TECHNICAL BULLETIN

Wiring and Dip Switches - ACC1800C

THIS TECHNICAL BULLETIN SUPERCEEDS ALL PREVIOUS TECHNICAL BULLETINS ON THE ACC1800C WIRING

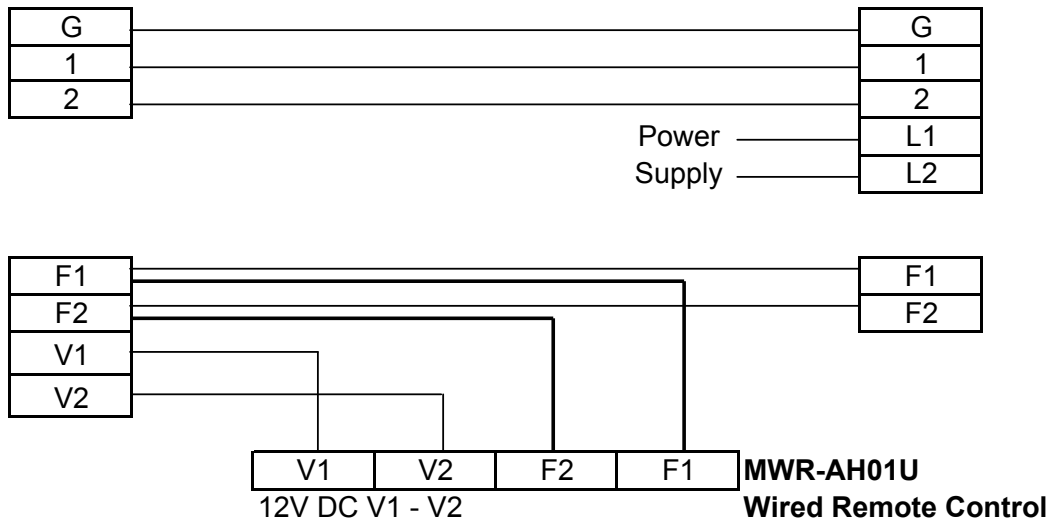
The wiring diagram in the unit Installation manual has been found to be incorrect It does not show the F1 & F2 wires connected from the indoor unit to the Wired Remote Controller - MWR-AH01U - **THESE MUST BE CONNECTED**

Power Wiring : 14 AWG

Control Wiring : 18 AWG SHIELDED

KEEP ALL CONTROL WIRING 6" APART FROM ALL HIGH VOLTAGE WIRING AND FIXTURES - DO NOT RUN CONTROL WIRING THROUGH AREAS OF HIGH ELECTROMAGNETIC INTERFERENCE

CHECK THE TIGHTNESS OF ALL THE MOLEX PLUGS ON THE INDOOR AND OUTDOOR PCB BOARDS, ESPECIALLY THE F1/F2 CONNECTION ON THE INDOOR PCB - ENSURE THAT IT IS SNAPPED TIGHT
